Zoning & Subdivision Committee
Thursday, November 10, 2016, 12:30 pm

- Minutes from last meeting of October 13, 2016
 1. Review of Jerome Village GPN-5 Phase 2 Final Plat (Union County) – Staff Report by Brad Bodenmiller
 2. Review of Jerome Village GPN-5 Phase 3 Final Plat (Union County) – Staff Report by Brad Bodenmiller

Staff Report – The Courtyards at Jerome Village AKA GPN-5

Re: Final Plat Review
The Courtyards at Jerome Village, Phase 2

THE COURTYARDS AT JEROME VILLAGE, PHASE 2

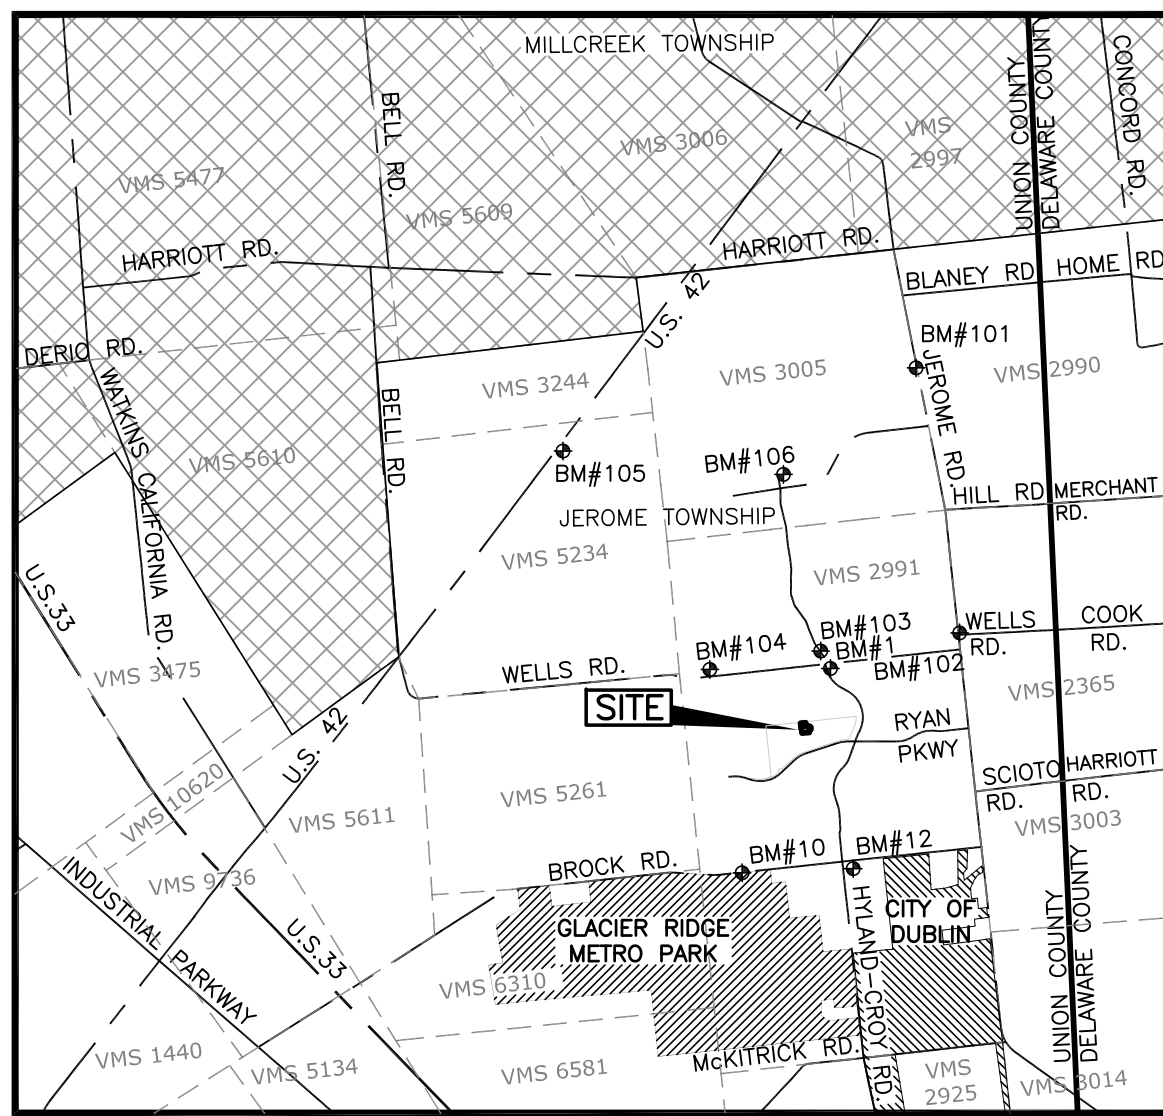
2. Sheet 1: The overall acreage in the situate description is 0.988 acres, not 0.731 acres.
3. Sheet 2: The bearing on the northern phase boundary should be directed north and east, not south and west.

2. Sheet 1 – The overall acreage in the situate description is 0.988 acres, not 0.731 acres.
3. Sheet 2 – The bearing on the northern phase boundary should be directed north and east, not south and west.

- 1) Sheet 1 of 2
 - a) Request clarification to use road right-of-way for ingress and egress to said
platted utility easements.
 - b) Request locations with 10 feet or less of utility easement be granted usage of
road right-of-way for temporary work zone. (Example: storage of excavated
materials)
 - c) Note: The restrictive easements size limit excavating and moving equipment
to access and then maintain electrical facilities within the platted easements
until all lots are platted per Preliminary Plat Phase 1 drawing.

THE COURTYARDS AT JEROME VILLAGE, PHASE 2

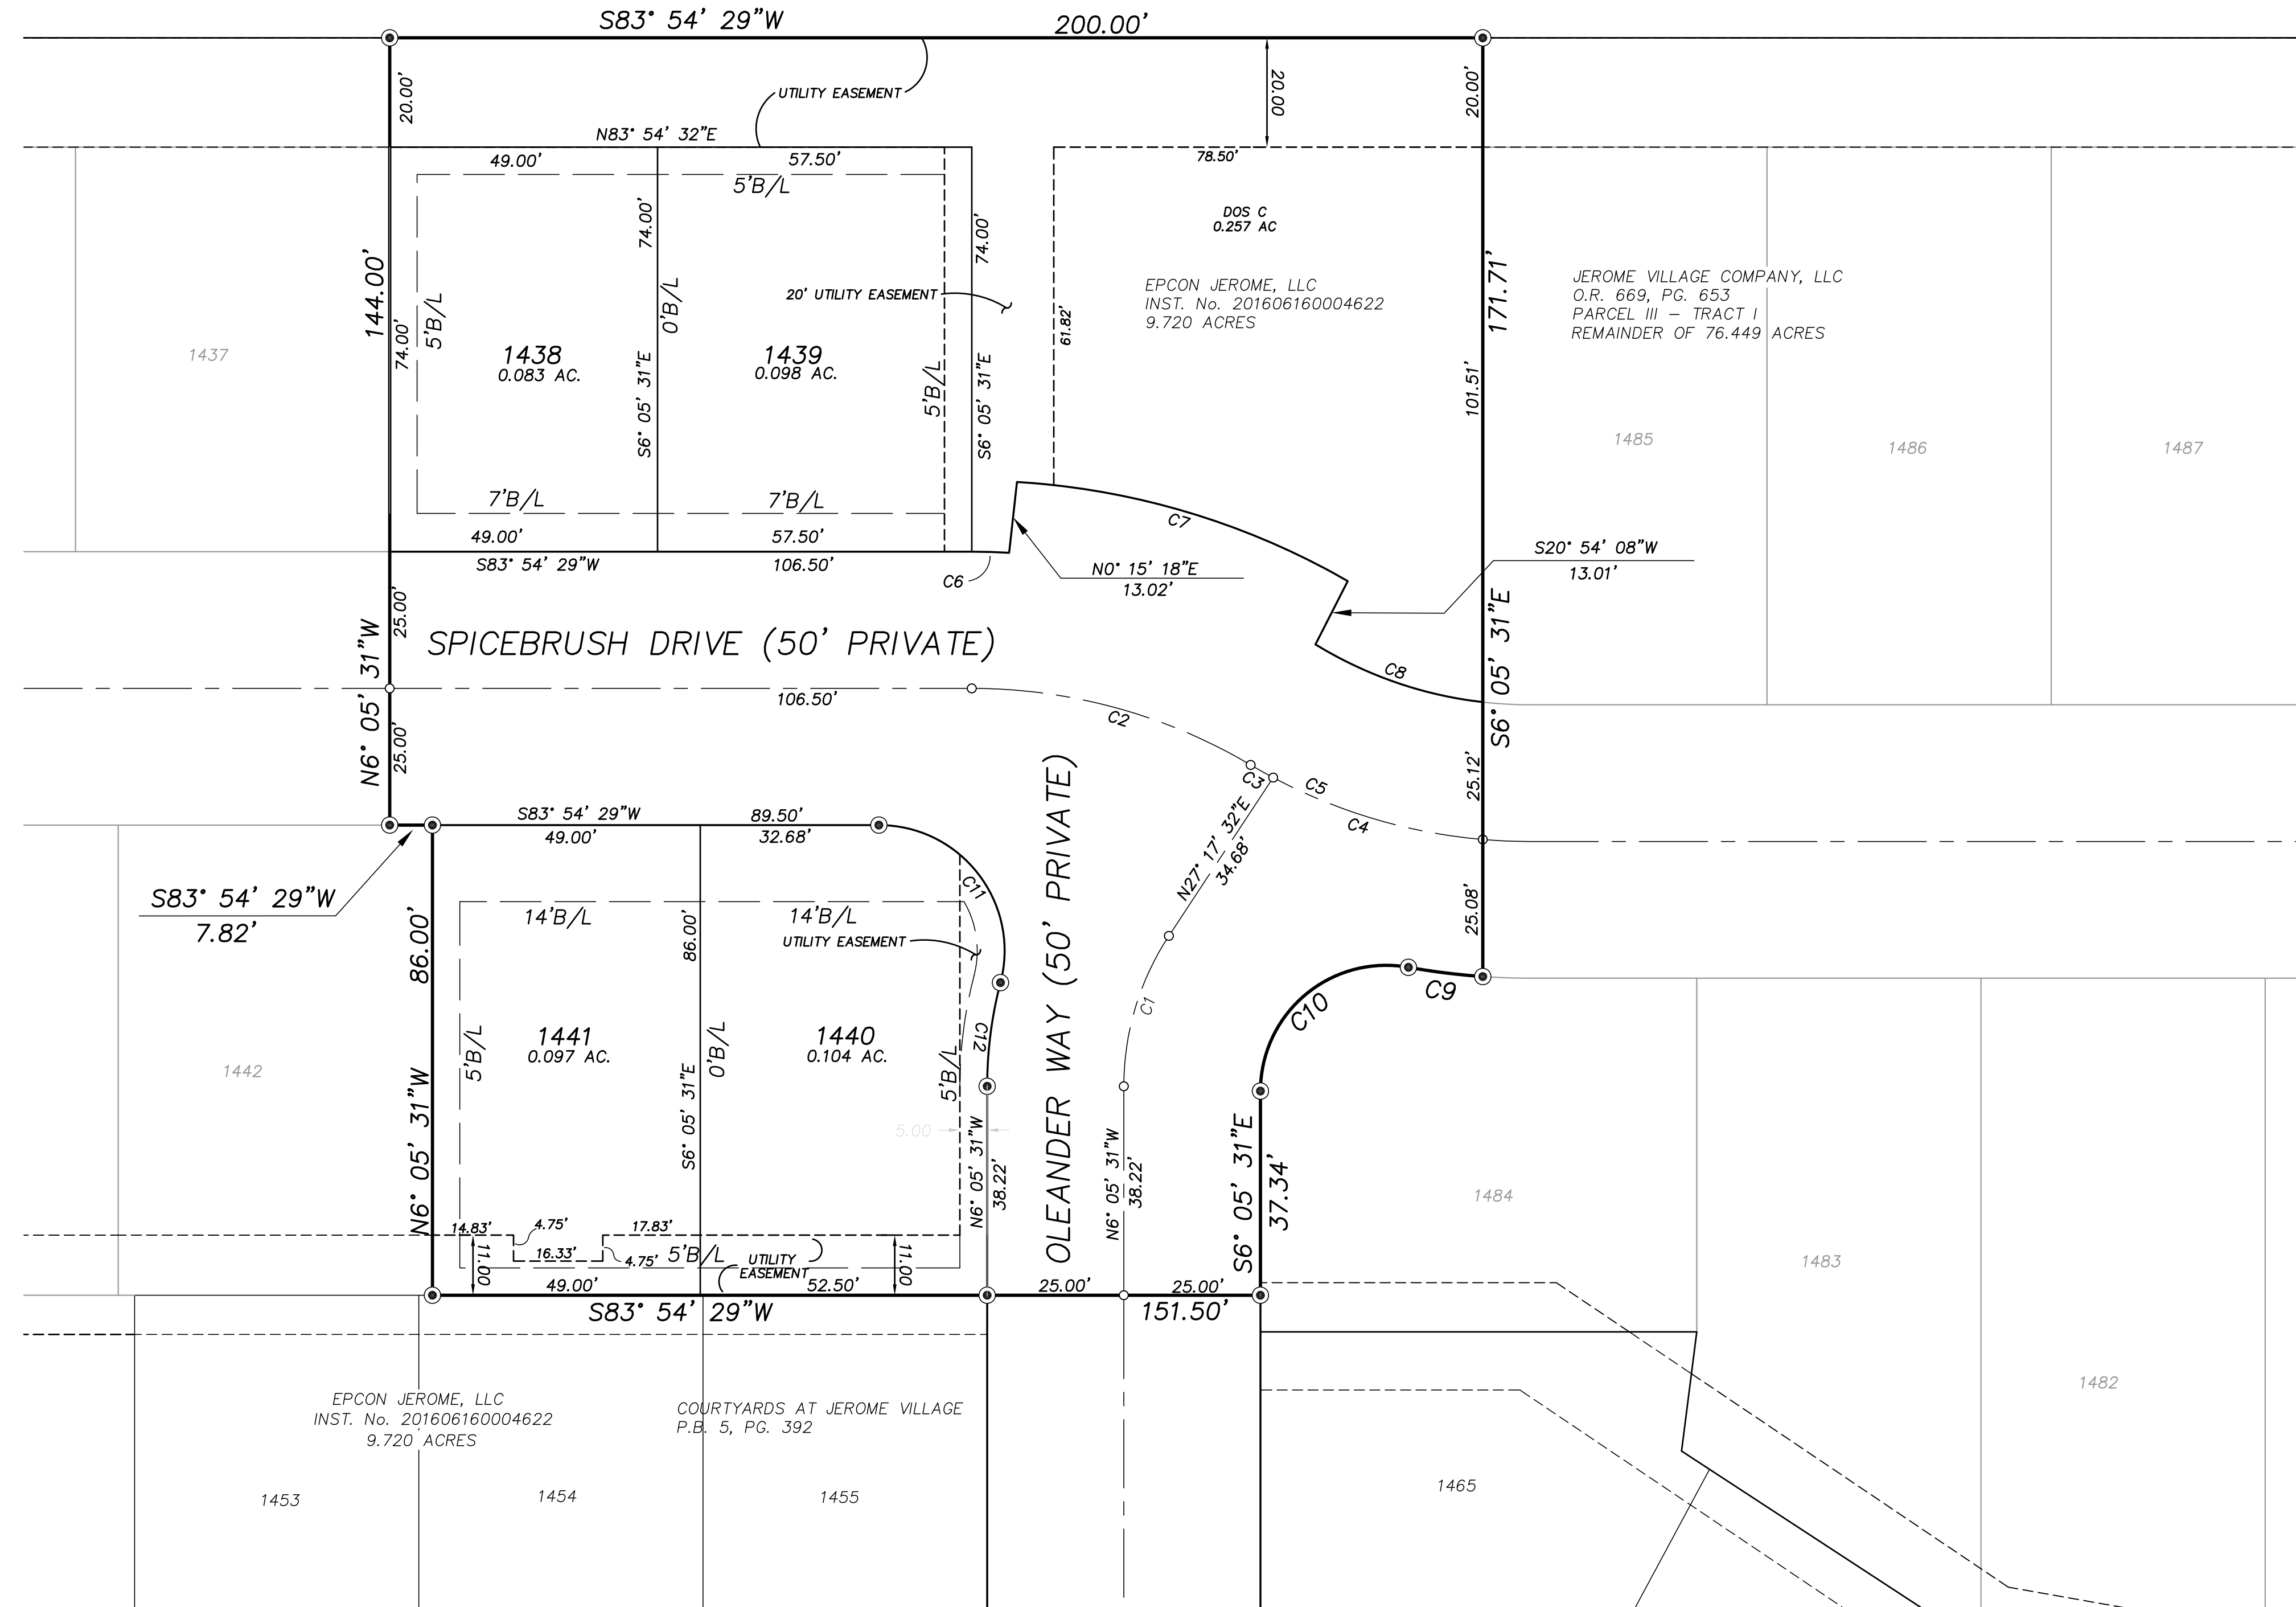
4. Sheet 2: Enlarge the "DOS C" open space designation and acreage.
5. Sheet 2: The adjoiner should reference the Amended Courtyards at Jerome Village Plat, and include pages 392A and 392B.

6. Sheet 2: The adjoiner referencing instrument number 201606160004622 should be moved outside of the phase 1 boundary, as it doesn't reference that area.

4. Sheet 2 – Enlarge the "DOS C" open space designation and acreage.
5. Sheet 2 – The adjoiner should reference the Amended Courtyards at Jerome Village Plat, and include pages 392A and 392B.

6. Sheet 2 – The adjoiner referencing instrument number 201606160004622 should be moved outside of the phase 1 boundary, as it doesn't reference that area.

- 2) Sheet 2 of 2
 - d) The 5 feet utility easement on lot 1440 is the reason for requested clarification
on sheet 1 above.
 - e) Noted lot number changes.

THE COURTYARDS AT JEROME VILLAGE, PHASE 3

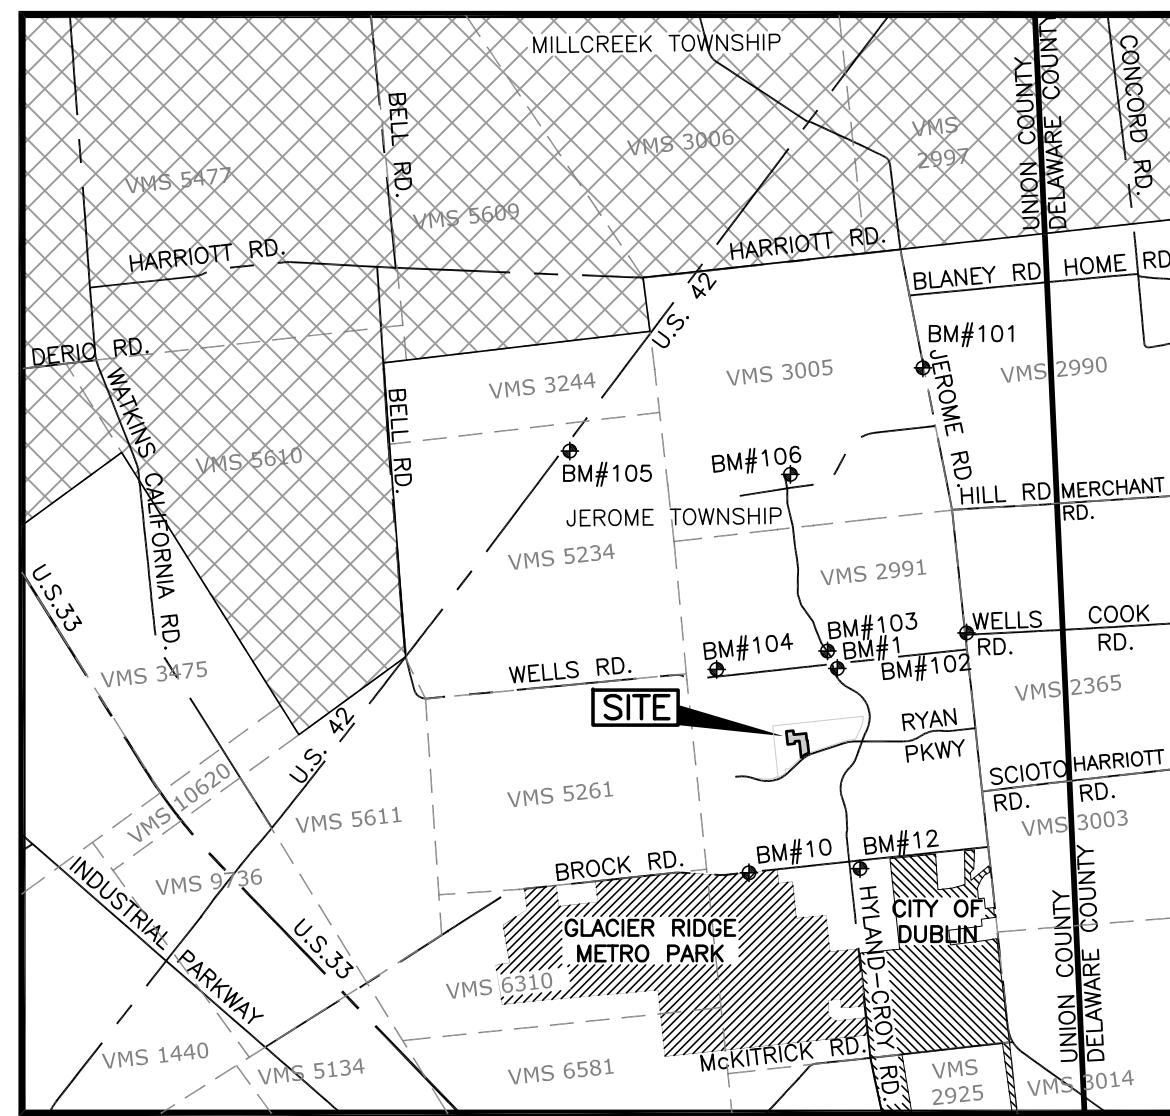
2. Sheet 1: The overall acreage in the situate description is 2.965 acres, not 0.731 acres.
3. Sheet 2: Revise the lineweights similar to other phases so there is a differentiation between build lines, easements, lot lines, etc.

2. Sheet 1 – The overall acreage in the situate description is 2.965 acres, not 0.731 acres.
3. Sheet 2 – Revise the lineweights similar to other phases so there is a differentiation between build lines, easements, lots lines, etc.

- 1) Sheet 1 of 2
 - a) Request clarification to use road right-of-way for ingress and egress to platted utility easements.
 - b) Request locations with 10 feet or less of utility easement be granted usage of road right-of-way for temporary work zone. (Example: storage of excavated materials)
 - c) Note: The restrictive easements size limit excavating and moving equipment to access and then maintain electrical facilities within the platted easements until all lots are platted per Preliminary Plat Phase 1 drawing.

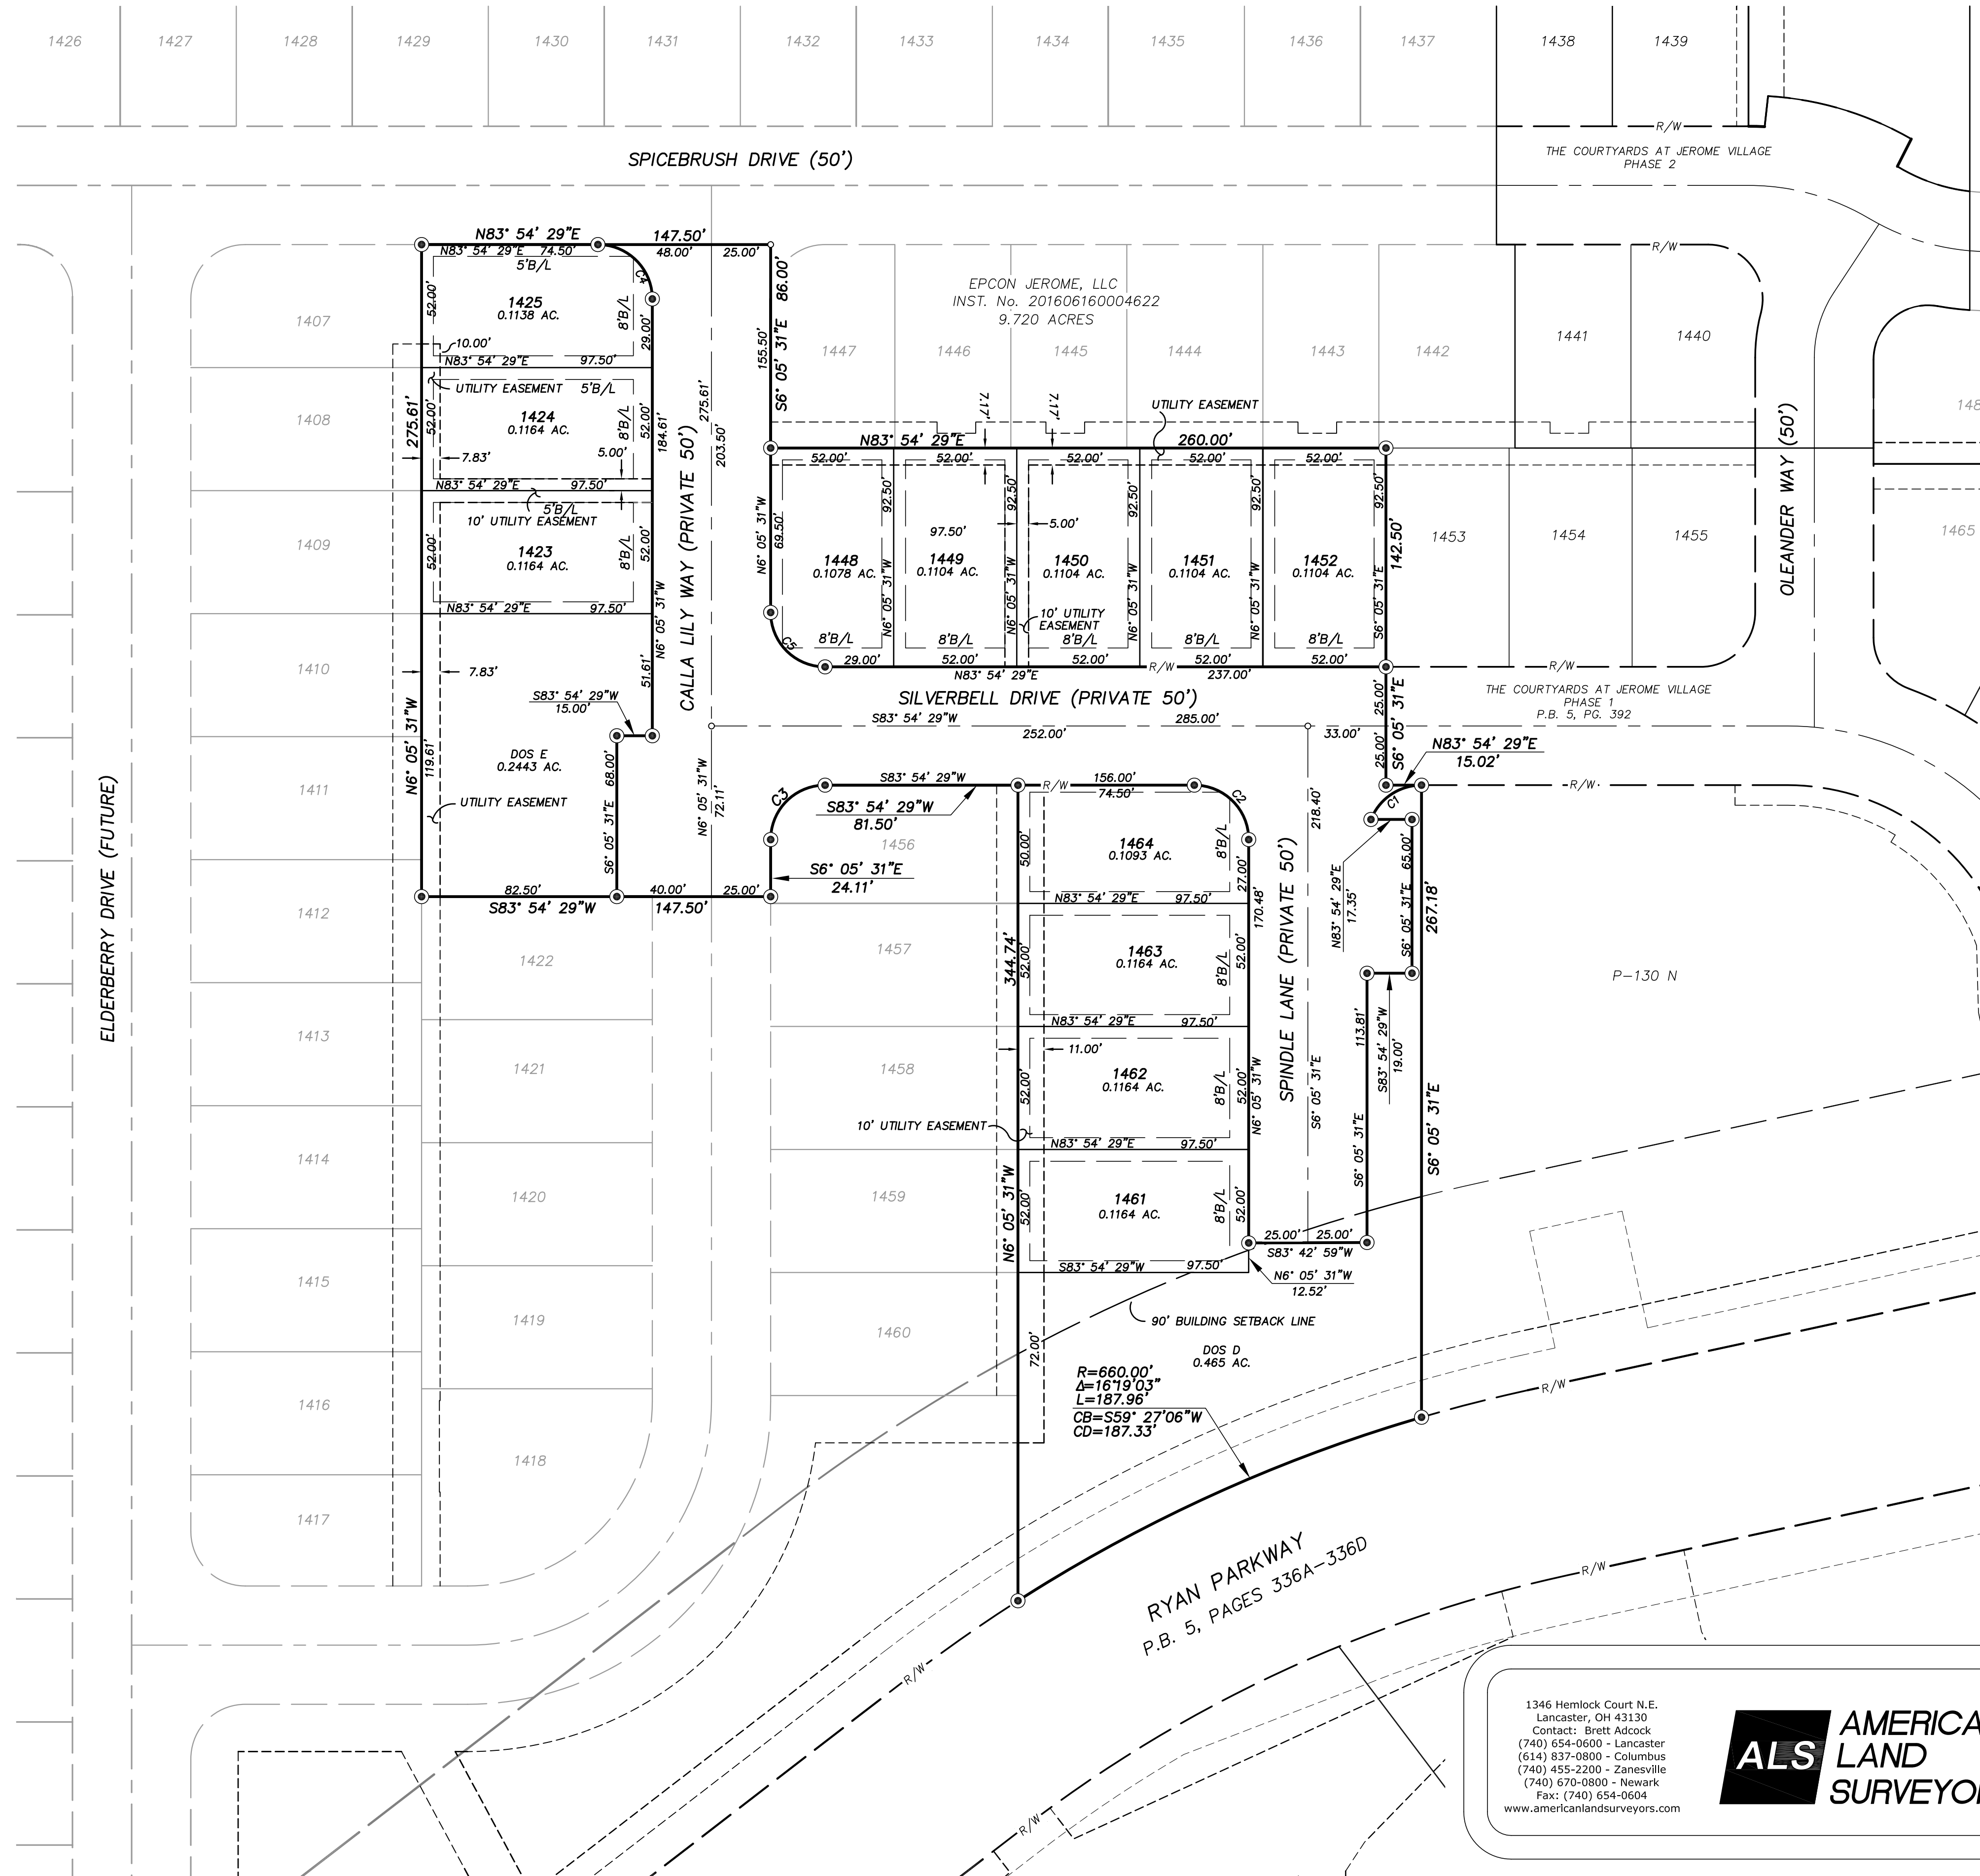
4. Sheet 2: the adjoiner should reference the Amended Courtyards at Jerome Vilalge Plat, and include pages 392A and 392B.
5. Sheet 2: The adjoiner area labeled "P-130 N" should be labeled "DOS-A."

6. The length annotation on the 10' easement line south of lot 1461 appears to be incorrect.

4. Sheet 2 – The adjoiner should reference the Amended Courtyards at Jerome Village Plat, and include pages 392A and 392B.
5. Sheet 2 – The adjoiner area labeled "P-130 N" should be labeled "DOS-A".

6. Sheet 2 – The length annotation on the 10' easement line south of lot 1461 appears to be incorrect.

- 2) Sheet 2 of 2
 - d) Request utility easement to extend through lots 1407 and 1425 to Spicebrush Drive right of way.
 - e) Request clarification for rear lot easements being 10 feet or 11 feet on lots: 1461, 1462, 1463 and 1464 along with Dos D
 - f) Noted lot number changes.
